Access Compliance Report

Public Rights-of-Way

(Curb Ramps)

Intersection ID: 6485	Main Street: CATHEY_RD	Cross Street: FIELDING_RD	Location: E
ADA ID: 4ED7713F0BA9	Ramp Type: Perp	Initial Pass/Fail: Fail	Overall Compliance: No
			Severity Score: 21.25

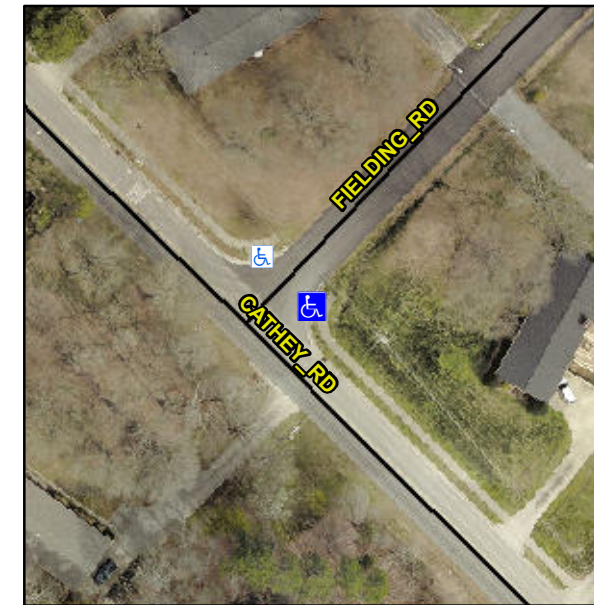
Not Found, R304.5.1, R304.2.2

Compliance	Description	Data	Compliance	Description	Data
N/A	Ramp Length (in)	50.0	No	Ramp Slope (%)	9.1
No	Ramp Width (in)	47.0	Yes	Ramp XSlope (%)	0.3
N/A	Flare Type LT	N/A	N/A	Flare Type RT	N/A
N/A	Flare Slope LT (%)	N/A	N/A	Flare Slope RT (%)	N/A
N/A	Flare Traversable LT?	N/A	N/A	Flare Traversable RT?	N/A
N/A	Landing Length (in)	N/A	N/A	DWS Provided?	N/A
N/A	Landing Width (in)	N/A	N/A	DWS Contrast?	N/A
N/A	Landing Slope (%)	N/A	N/A	DWS Length (in)	N/A
N/A	Landing X Slope (%)	N/A	N/A	DWS Full Width?	N/A
N/A	Landing Curb? (Y/N)	N/A	N/A	DWS Offset (in)	N/A
N/A	Shared Landing?	N/A			
N/A	Gutter Ponding?	N/A	N/A	Gutter Slope (%)	N/A
N/A	Gutter Lip Ht (in)	N/A	N/A	Gutter X Slope (%)	N/A
N/A	Painted X Walk1?	No	N/A	Painted X Walk2?	N/A
	X Walk 1 Direction	To NW		X Walk 2 Direction	N/A
N/A	X Walk 1 Width (in)	N/A	N/A	X Walk 2 Width (in)	N/A
	X Walk 1 Slope (%)	0.9		X Walk 2 Slope (%)	N/A
	X Walk 1 X Slope (%)	1.3		X Walk 2 X Slope (%)	N/A

Remove & Replace Entire Ramp.
